**Attention: Docket ID Number EPA-OAR-2015-0216**

**Re: Environmental Protection Agency's (EPA's) "Release of Draft Control Techniques Guidelines for the Oil and Natural Gas Industry" at 80 FR 56577 (September 18, 2015)**

# **API Comments on the Draft Control Techniques Guidelines for the Oil and Natural Gas Industry**

**December 4, 2015**

**Figure 2-1 CTG Cost of Control – Reciprocating compressors at Gathering and Boosting Stations**

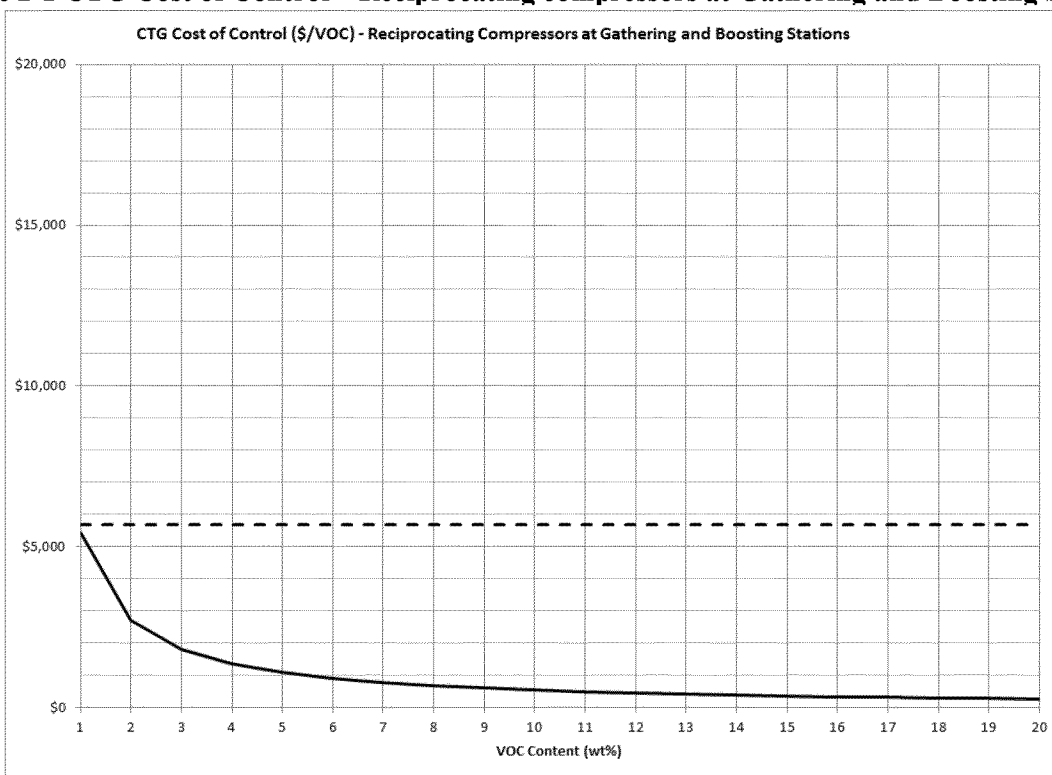
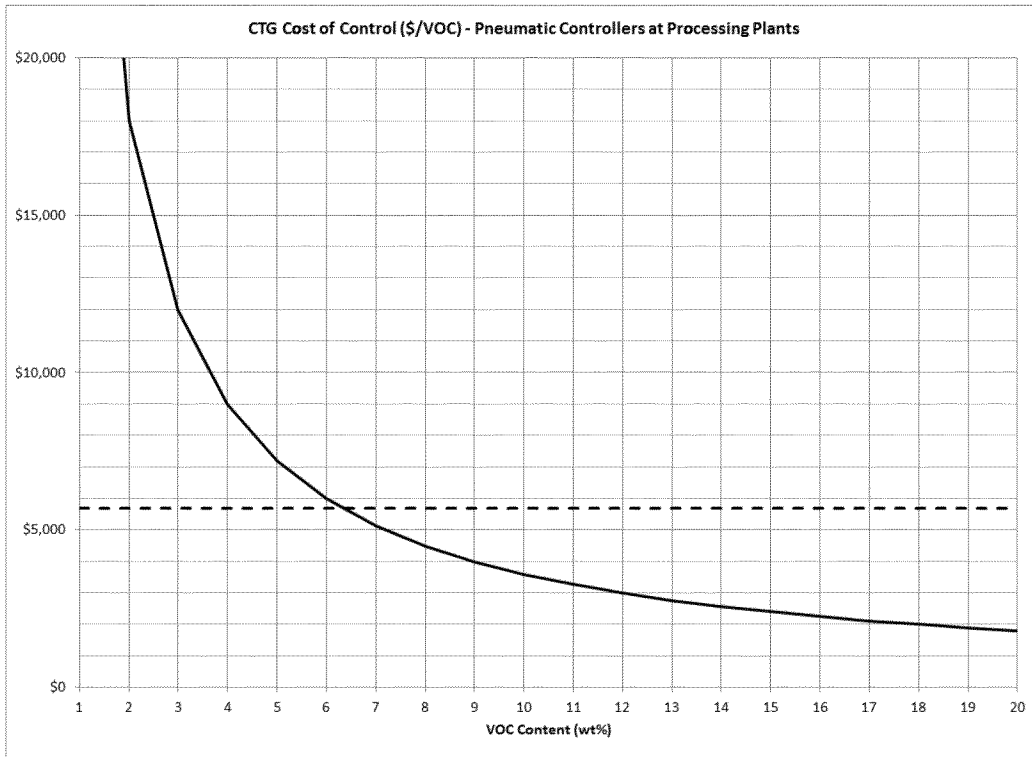
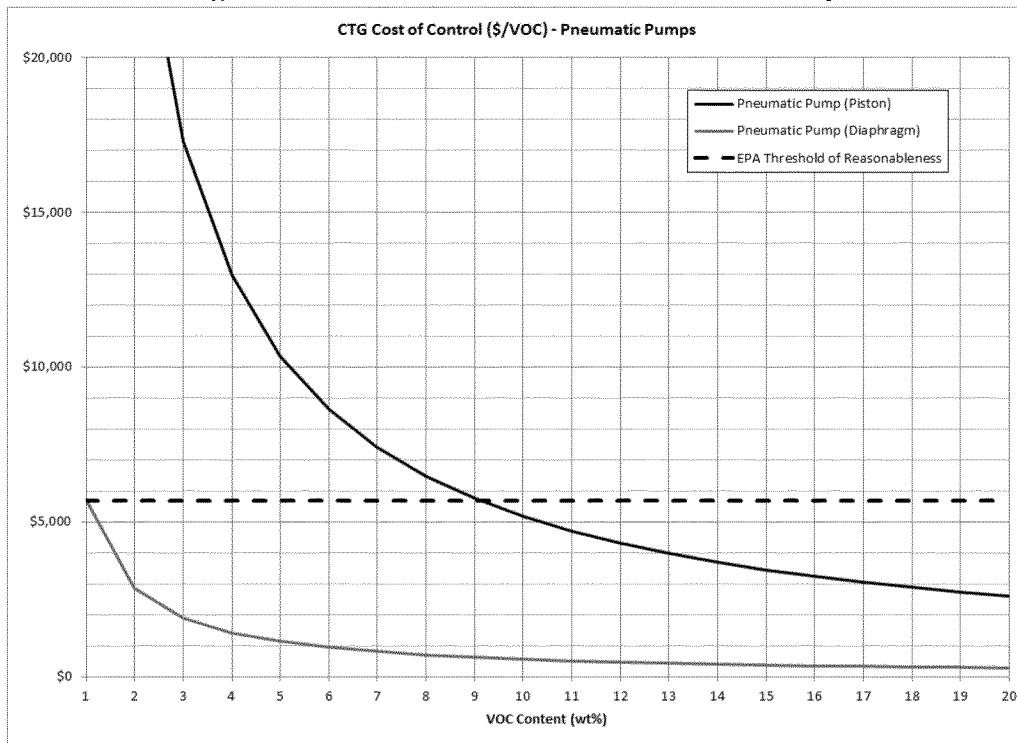
As noted above, EPA’s representative gas composition consisted of 6.8% VOC by volume and 18.3% VOC by weight. The cost effectiveness values that were provided in Table 2-1 were based on emissions calculated using these weight percentages. Cost effectiveness values were calculated at varying concentrations of VOC by assuming a linear relationship between VOC emission reductions and the VOC content. Figure 2-1 through Figure 2-4 show the results of this analysis. For reciprocating compressors at processing plants and pneumatic controllers at well sites, EPA estimated that there would be net savings due to the recovery of natural gas. These sources were not included in this analysis.

- For reciprocating compressors at gas processing plants, the cost effectiveness is below \$5,700 for VOC concentrations down to 1% by weight.
- The cost effectiveness for fugitive emissions control at oil well sites is greater than \$5,700 and thus unreasonable at all VOC concentrations.
- For pneumatic controllers and LDAR at gas processing plants, pneumatic piston pumps, and fugitive emissions at natural gas well sites and gathering and boosting stations, the cost effectiveness rises above \$5,700 at VOC concentrations about 6 and 7% by weight.

Figure 2-5 Cost of Control Using API Estimates – Pneumatic Pumps

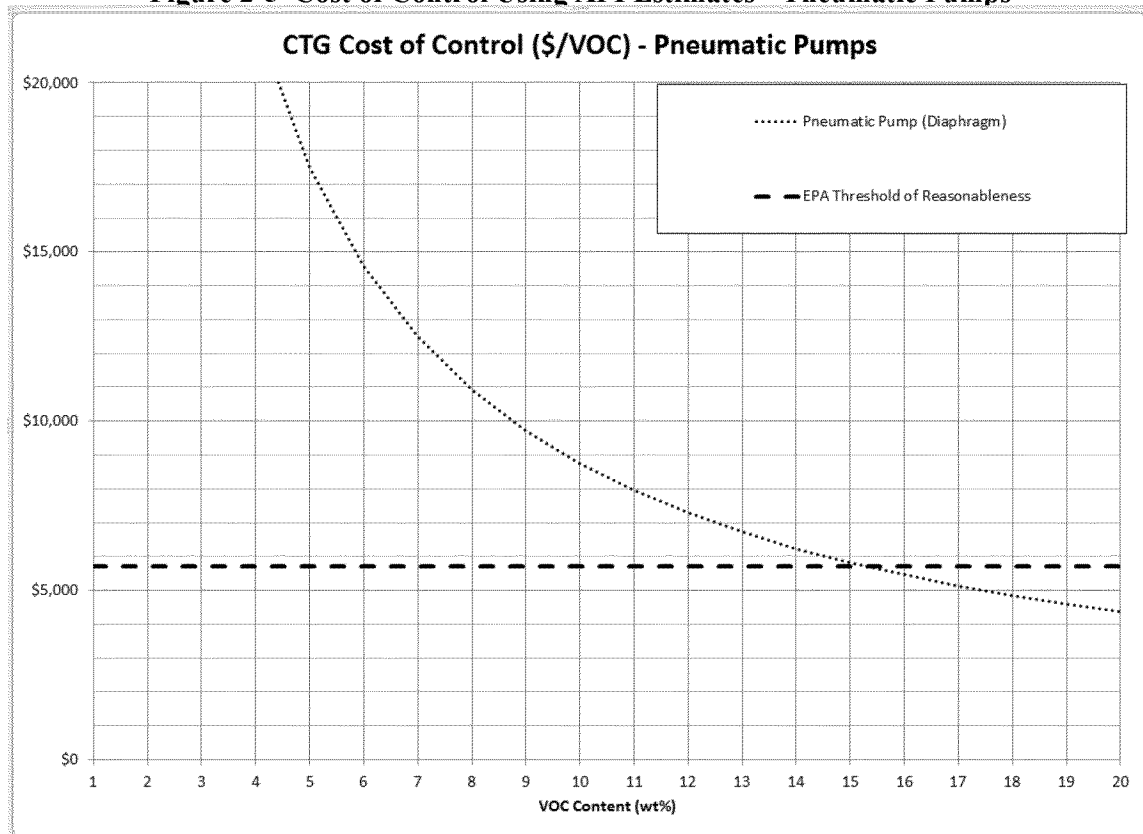
As seen in Table 2-4, the cost effectiveness values for EPA's draft RACT recommendations for fugitive emissions programs at well sites and for pneumatic piston pumps are well above EPA's reasonableness threshold of \$5,700/ton. The diaphragm pneumatic pumps are below this threshold. However, this cost effectiveness is based on the 18.3% by weight VOC content in EPA's representative composition. As discussed above, many areas have gas compositions much lower than this level. Figure 2-5 illustrates the cost effectiveness at different VOC composition levels. As can be seen, the cost effectiveness crosses the \$5,700 reasonableness threshold at around 15% VOC by weight.

**Figure 9-1 Current EPA Flare Velocity Limits**

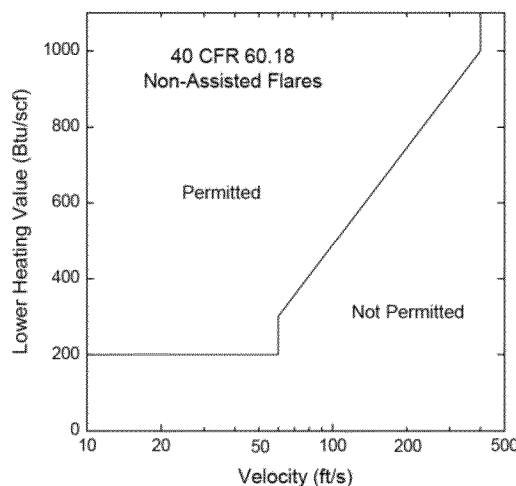
The velocity limits in 40 CFR 60.18 were originally promulgated on January 21, 1986 and are graphically depicted below. The figure shows flame exit velocities in feet-per-second (fps) along the x-axis and lower heating value of the waste gas in Btu per standard cubic feet (scf) along the y-axis. A minimum heat content is required of 200 Btu/scf for unassisted flares or 300 Btu/scf for assisted flares up to 60 fps, where the required heat content increases as a function of exit velocity until a maximum allowable velocity of 400 fps is reached.

This relationship was developed following a series of EPA sponsored tests conducted in the 1980's that examined how various flare operating parameters, including velocity, affect flare performance. The tests with relevance to the current velocity requirements are the 1983 McDaniel<sup>15</sup> test and the 1984 Pohl<sup>16</sup> test. The focus of the 1985 Pohl<sup>17</sup> and 1986 Pohl<sup>18</sup> studies was not on high velocity, but any test runs from these studies where the exit velocity of the flare was greater than 60 feet per second (fps) have been included in this analysis.

**Figure 9-2 A Comparison of Combustion Efficiency vs Velocity for McDaniel 1983**  
**McDaniel 83 CE vs. Velocity**

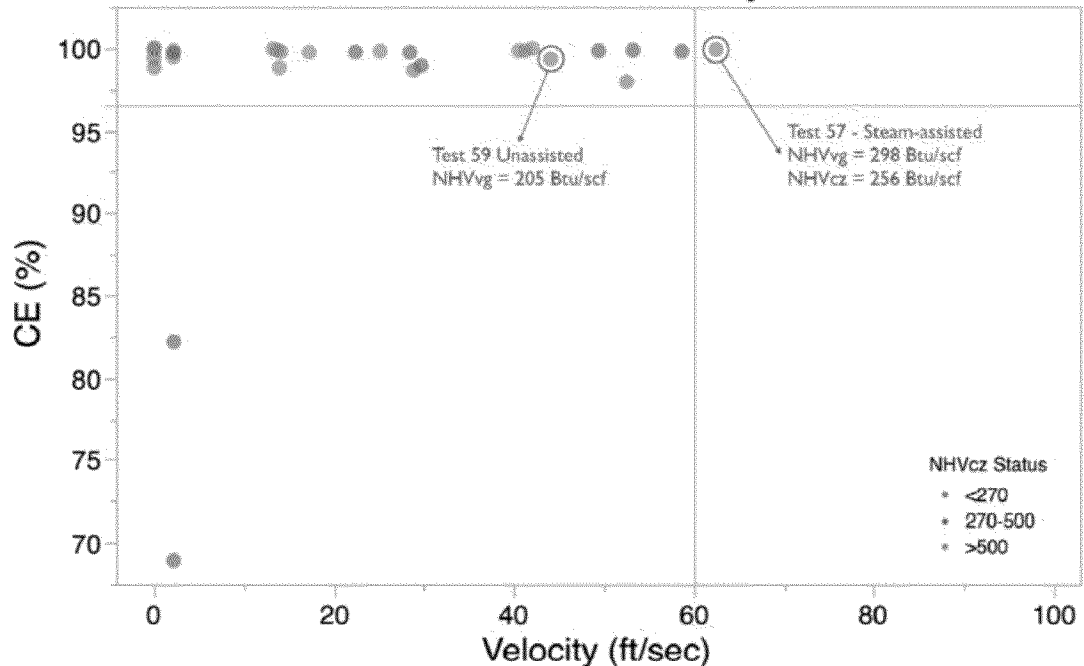
based on a single data point -- McDaniel 1983<sup>15</sup> test 57. The 200 Btu/scf limit for unassisted flares was also set based on a single data point – McDaniel test 59. These tests were performed on an 8.6-inch steam-assisted flare fueled with a propylene/nitrogen mix. The data are shown in

McDaniel did not collect data at velocities higher than 60 fps. At the 60 fps upper limit of the data, combustion efficiency remained very high and with no evidence of a trend toward lower combustion efficiency. These data were used to establish the 60 fps velocity limit although there is no evidence that operating at higher velocities results in degraded combustion efficiency.

Figure 9-3 A Comparison of Combustion Efficiency vs Velocity for Pohl 1984

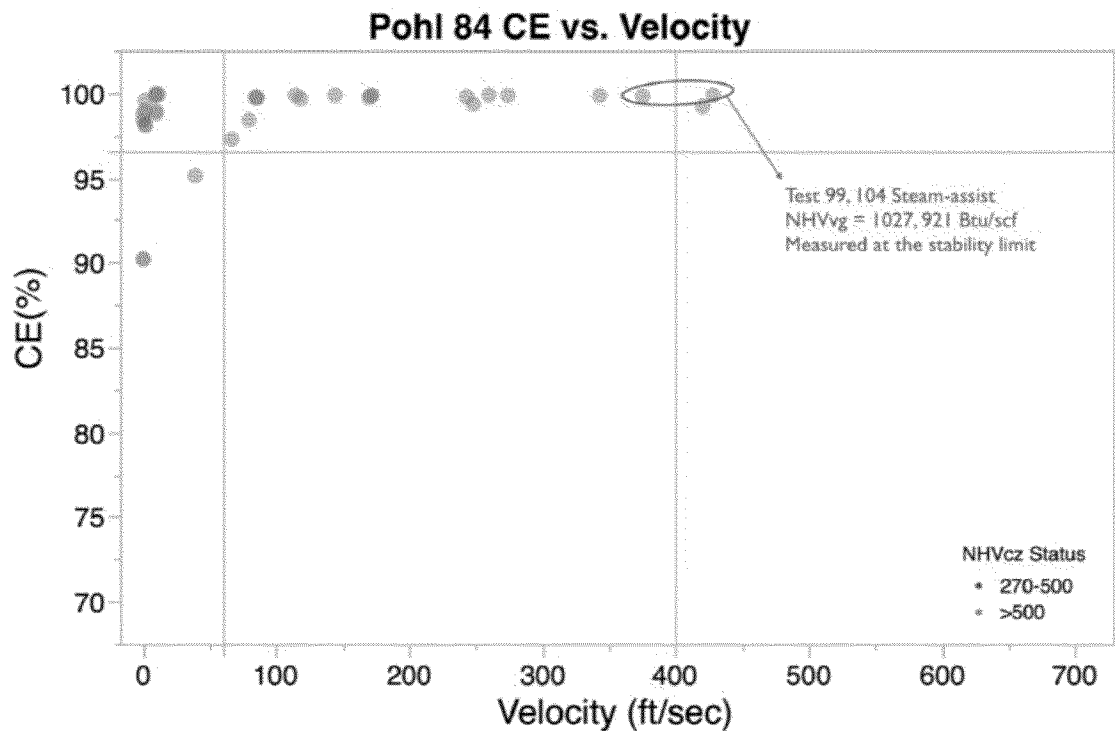
The 400 fps, 1,000 Btu/scf limit appears to be set based on two data points from flame stability test runs 99 and 104 from Pohl 1984.<sup>16</sup> That study was performed on a 3-inch steam assisted flare fueled with a propane/nitrogen mix. These data are shown in

Similarly to the data used to establish the 60 fps limit, data collected in this study were not collected at velocities higher than the upper limit of 400 fps. As in McDaniel 83, Pohl 84 showed no evidence of a trend towards lower combustion efficiency at the upper velocity limit measured. These data were used to establish the 400 fps limit although there is no evidence that operating at higher velocities results in degraded combustion efficiency.

**Figure 9-4 A Comparison of Combustion Efficiency vs Velocity for All Publicly Available High Velocity Flare Tests binned by NHVcz Range**

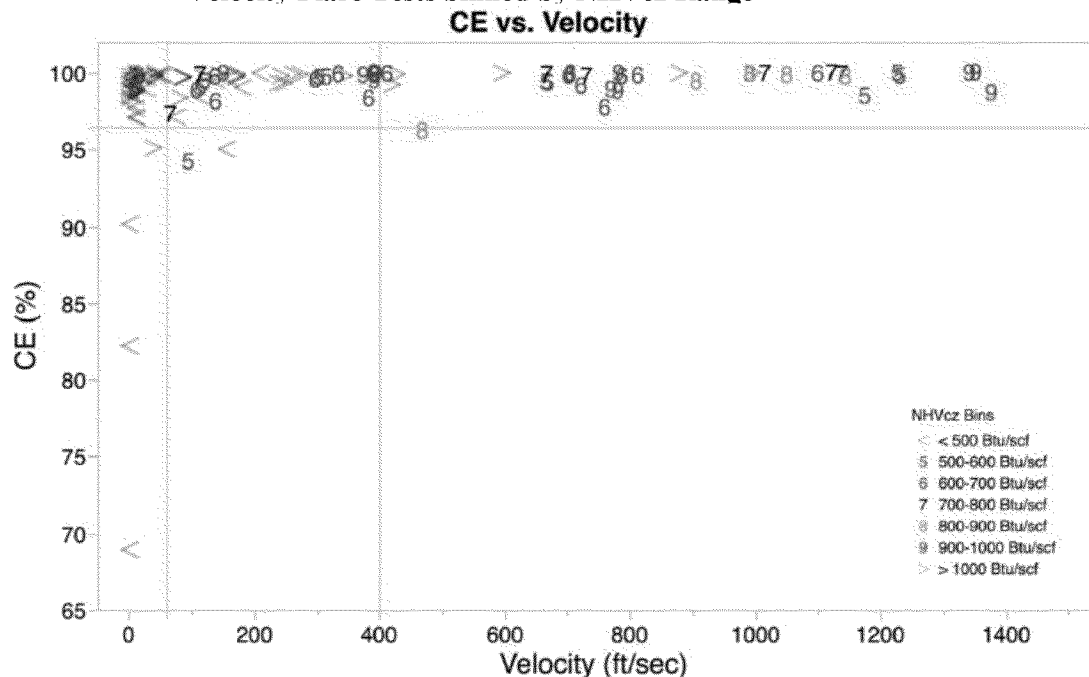
Figure 9-4 shows all data from publically available high velocity flare tests as of October 2014. Some low velocity data are also included to the extent that they were measured during a test series including high velocity data. Data includes the 1980's flare studies referenced above as well as more recent studies (Marathon Garyville<sup>19</sup> and Dow<sup>20</sup>). This data is similarly displayed based upon combustion efficiency (CE) as a function of exit velocity in fps. The data is binned by combustion zone net heating value (NHVCZ) in groups of 500 Btu/scf. Only data with NHVcz > 270 are included.

Almost all of the low velocity data that also have low CE have NHVcz values less than 500 Btu/scf. Additionally, virtually all of the test runs with velocity greater than the current limit of 400 fps, were conducted at NHVcz values less than the current 1,000 Btu/scf limit. This graph clearly shows that high combustion efficiency above the current limits is not only possible, but that it is assured based upon available test data.

All of the data collected, including the data used previously to set current limits as well as recently collected data, show that high velocity flaring results in high flare combustion efficiency (>96.5%). Previous limits were based solely on lack of data at higher flare exit velocities. There is no indication either in the 1980's studies or the more recent flare studies that high velocity flaring contributes to poor combustion efficiency.

**Figure 9-5 A Comparison of Flame Lift-Off and Combustion Efficiency from Pohl 84**

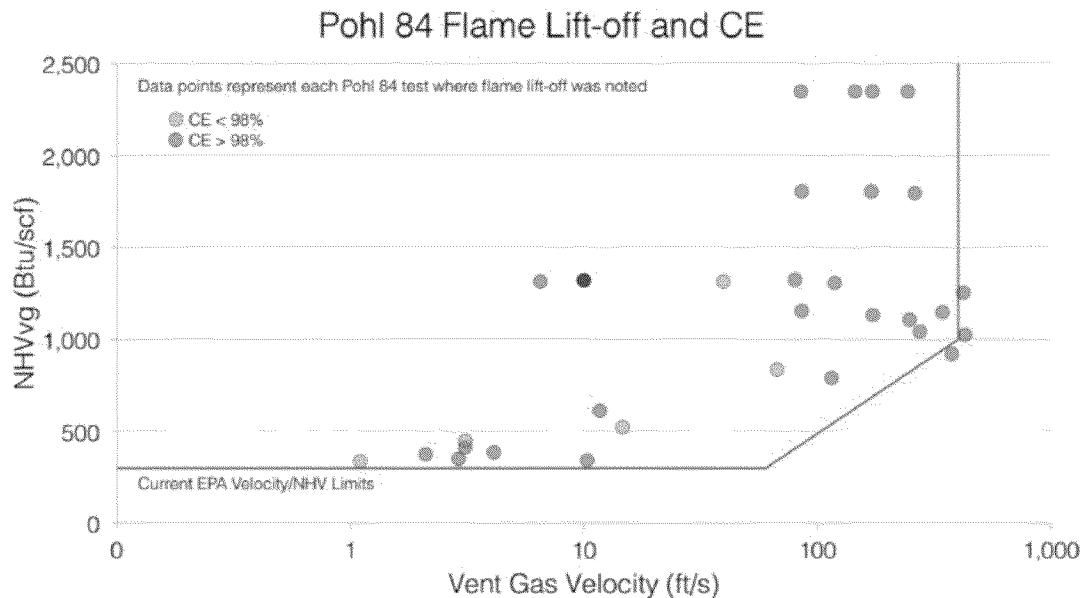
efficiency. Figure 5 shows every data point from Pohl 84 where flame lift-off was noted in the report.

27 of the 32 lifted flames showed high combustion efficiency. None of the remaining five points had measured combustion efficiency below 91%. Figure 9-5 clearly shows that flame lift-off does not affect combustion efficiency over a wide range of velocities and net heating values.
